**Oxfordshire Highways**

# **Cogges Link Road Geomorphology Study**

B0834600/Doc/CLR/Geo April 2008

Drawing Number  
**FIGURE 5**

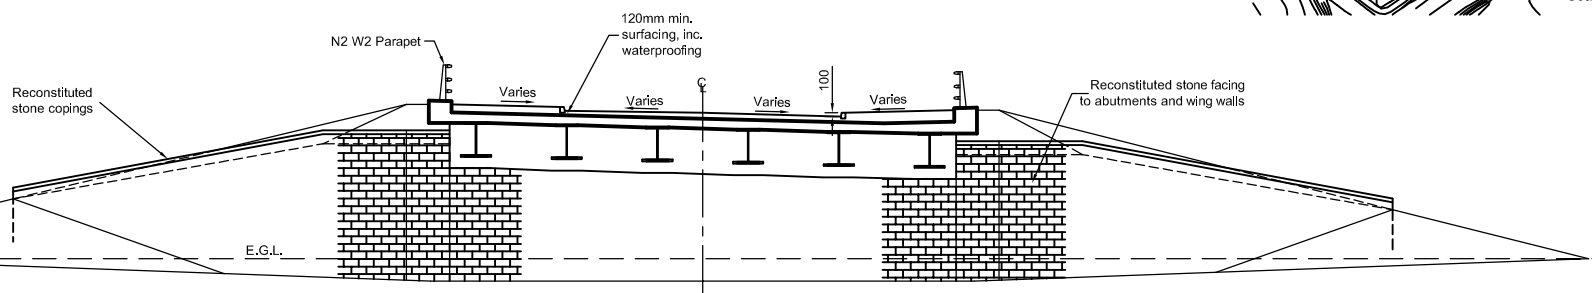
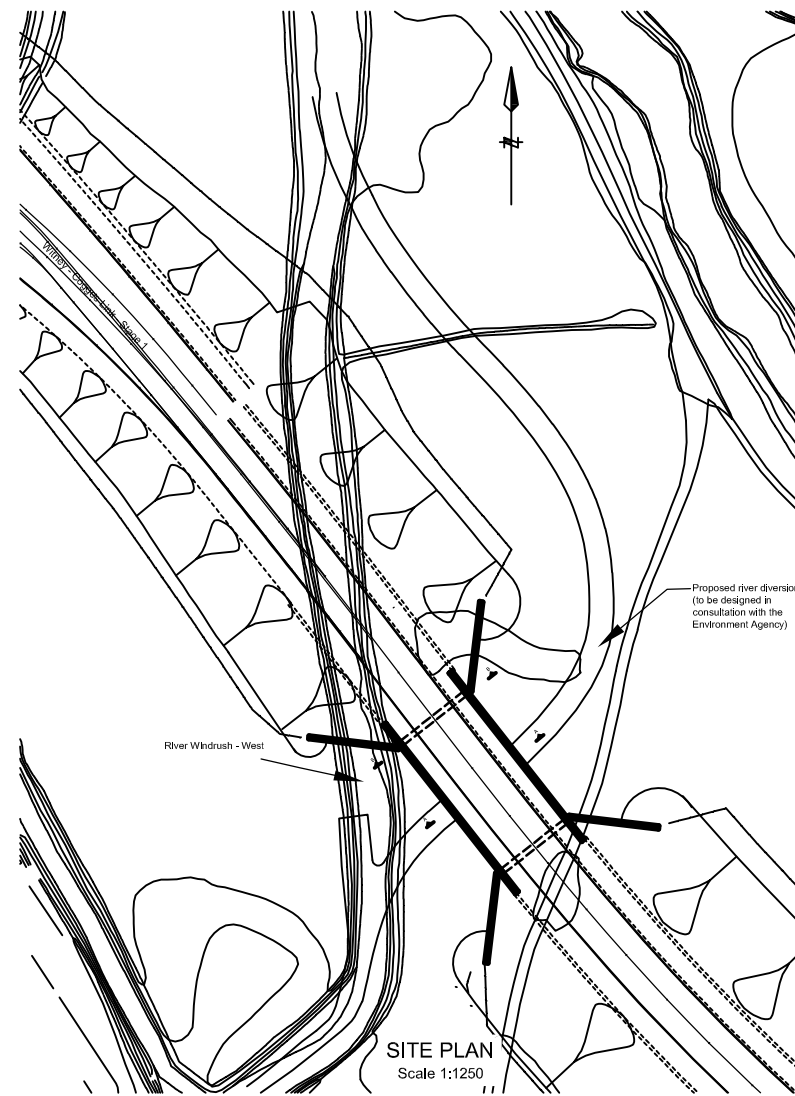
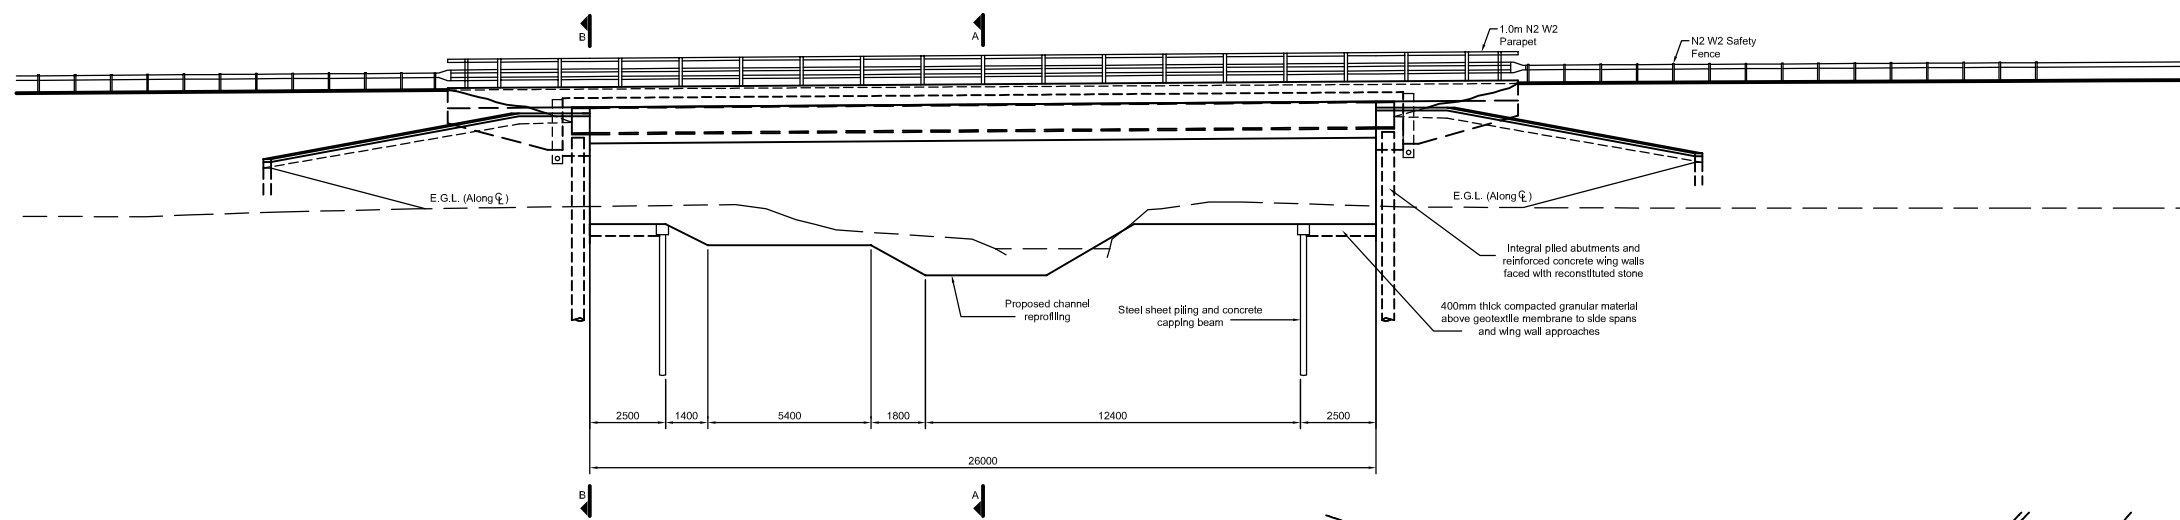
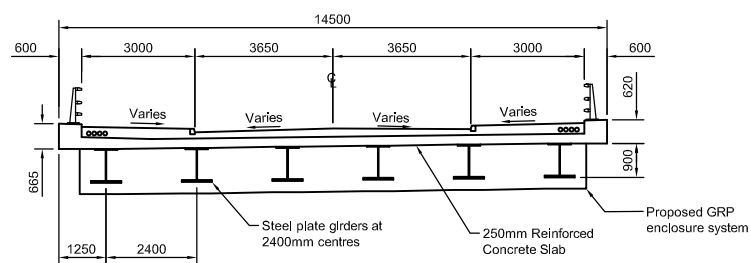
5.1.2 The road would require a diversion of around 70m of the western branch of the River Windrush. Currently the proposals show the river diversion having three very sharp bends, two to allow passage under the bridge and one to rejoin the eastern branch downstream of the bridge. It is unlikely that this degree of bend sharpness would develop under any natural circumstances. Whilst it could be possible in this particular location for the diverted channel to remain in this form as the river has very low energy (and therefore the risk of erosion is negligible) it is not recommended that a diversion of this shape should be constructed. It would be preferable that a more natural channel form be developed that enhances the current geomorphological processes that are operating in the reach (ie largely depositional). A form could be constructed that encouraged the natural deposition of sediment on the inside of the bend and a steeper outer bank line is recommended. A steep bank would also be beneficial habitat both for kingfishers and water voles. There is no reason to use any form of bank protection in the reach since it is predominantly undergoing deposition and the diversion would actually encourage this further through the creation of a reduced bed gradient. Preliminary alternative outline designs for the proposed diversion, are detailed in section 6. Where the channel passes under the proposed bridge the recommended sheet piling will be more than sufficient to protect the bridge pier and thus no erosion protection mats would be necessary.

6.1.2 The revised diversion drawings of the western branch of the River Windrush depict three bends with a lower radius of curvature to channel width (Figure 7). In addition, on the inside of each of the bends a gentle slope from the top of the bank to the bed is proposed to encourage preferential deposition within the channel (on the inside of the bends). Steep outer bank profiles are recommended as they represent good habitat for both kingfishers and water voles and in this location, within a very low energy environment, there is negligible risk of adjustment occurring. This is further inhibited by the underlying geology which is a cohesive clay beneath a thin layer of alluvial material.

Drawing Number  
FIGURE 6

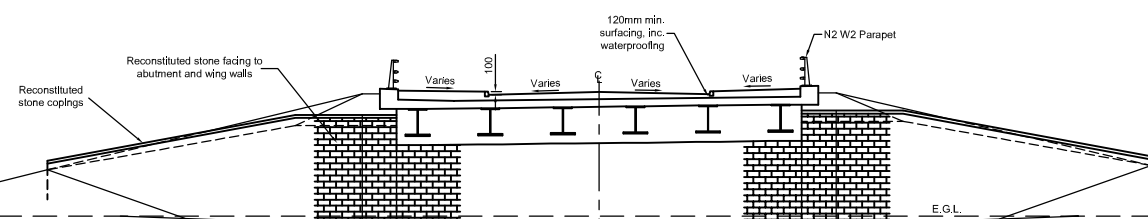
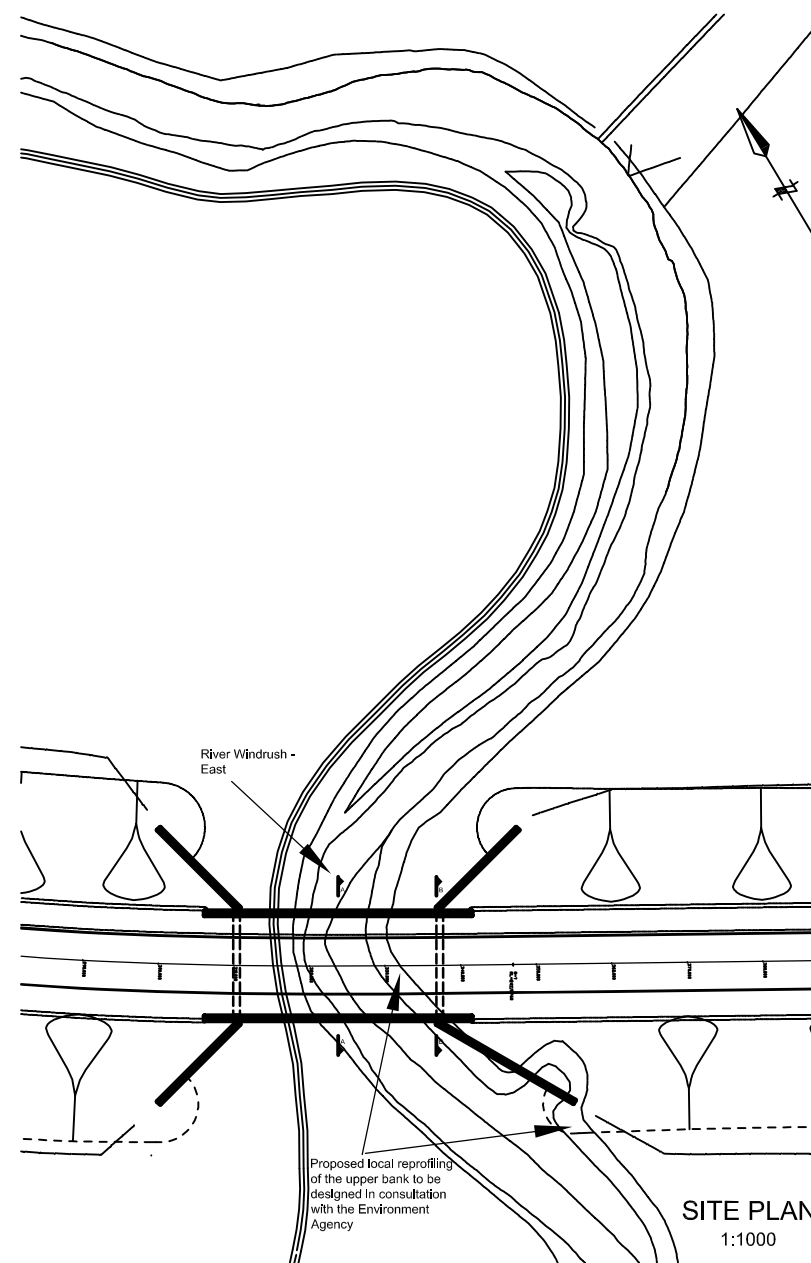
5.1.3 Under the existing plans only minor modifications are proposed to the Eastern Branch of the River Windrush (see Figure 6). This includes construction of a regular trapezoidal channel under the bridge. It is proposed that this would have erosion protection mats on both re-constructed banks. For the right bank (facing downstream) this would involve re-profiling of the bank from the current steeply graded bank face to a more gently graded slope (approximately 0.58). The left bank would be re-profiled to construct a two stage channel with a slope of 0.56 up to a lower flat area (5.4m in length) before a slope of 0.5 takes the ground level to an equivalent level on the left bank.

5.1.4 It is unclear as to why any re-profiling has been proposed for right bank. A presumption of doing nothing where possible should be followed to minimise impact to the existing river habitat and geomorphological processes operating at the site. On the right bank there is no reason to re-profile except to fill in the currently eroded section. The design drawings show a 5m depth of sheet piling along the bank face to protect the bridge piers. This depth is more than adequate to cope with any scour at the bank toe (thought to be about 2m depth maximum). While there is no geomorphological reason to re-profile the left bank

as it is on the inside of the bend (ie likely to be depositional and thus there is no risk of erosion occurring at this location) this is being undertaken for other purposes.

6.1.3 No modification is recommended to the current channel form on the Eastern Branch and thus no revised figure is detailed. If the sheet piling on the right bank is too close to the current bank edge then it might be necessary to backfill behind the sheet piling in the currently eroded section that has been created by a tree fall. Otherwise minimal interference to the current bank form is recommended. The upper section of the left bank is being re-profiled for other purposes. This should be undertaken with as minimal interference to the bank form as possible.

Drawing Number  
**FIGURE 8**

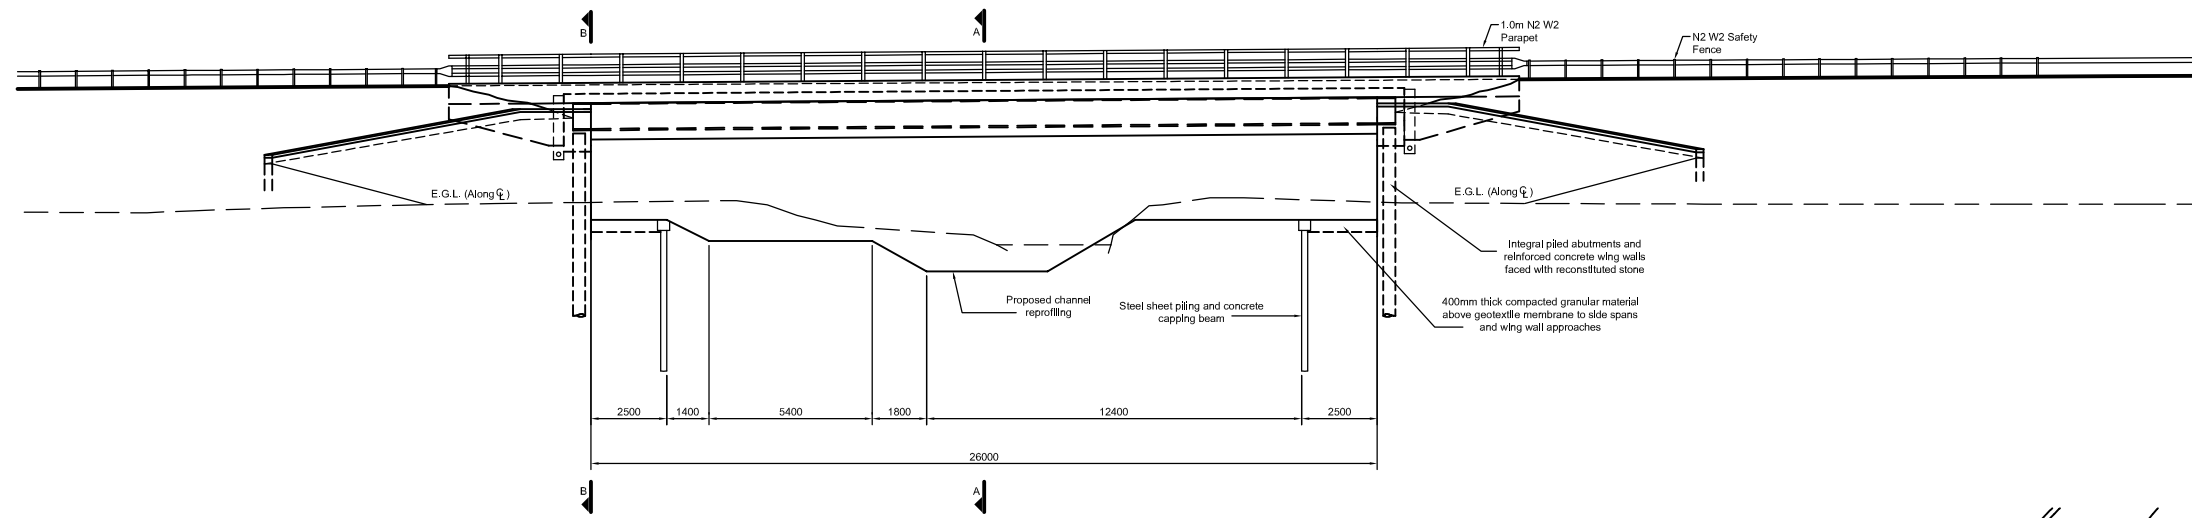
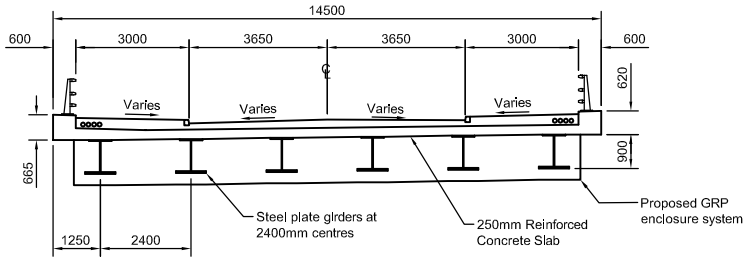
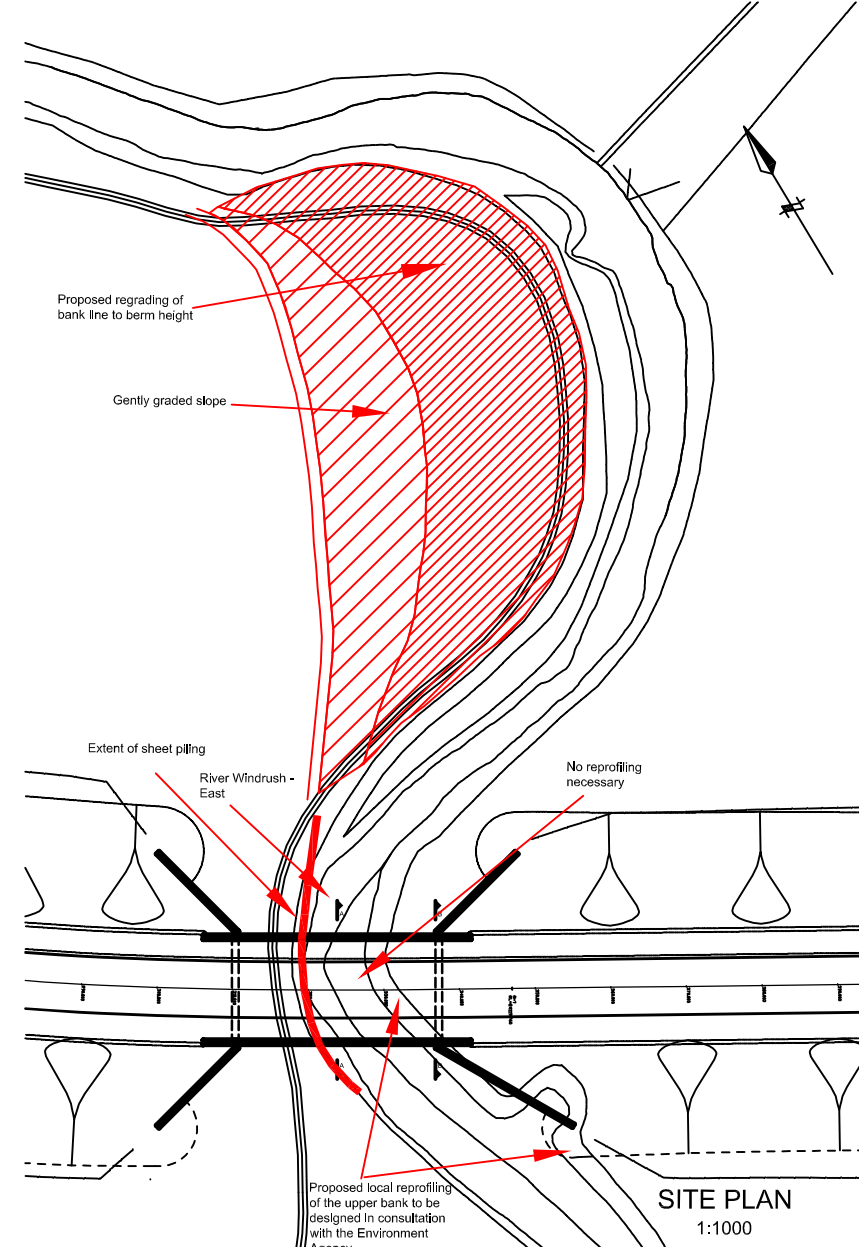
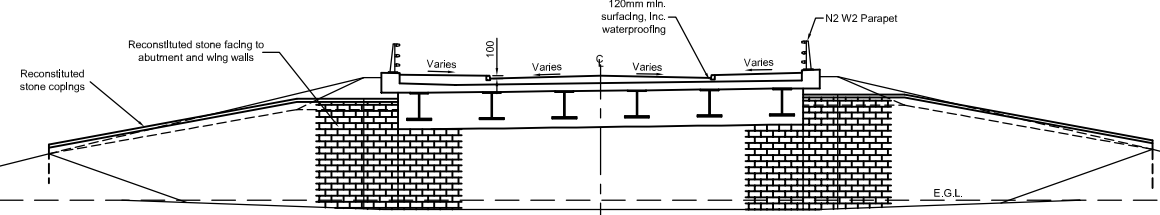
Potential enhancement measures for the loss in wetland area caused by the proposed road crossing include realignment of the right bank (facing downstream) of the channel on the Eastern Branch of the River Windrush upstream of the proposed bridge crossing (Figure 8). This would have multiple benefits. Firstly, through removing the right bank to the elevation of the low berm there would be an increase in the frequency with which this area of the floodplain interacts with the river. This would increase habitat diversity. Secondly, lowering this area of land would also allow a more natural flood regime to develop in the immediate vicinity of the river and enable flood flows to pass at a more perpendicular angle to the bridge. The material extracted from this area could be used in the road structure, or alternatively, be used to fill the channelised section of the Western Branch that would become redundant with the new realignment of this reach.
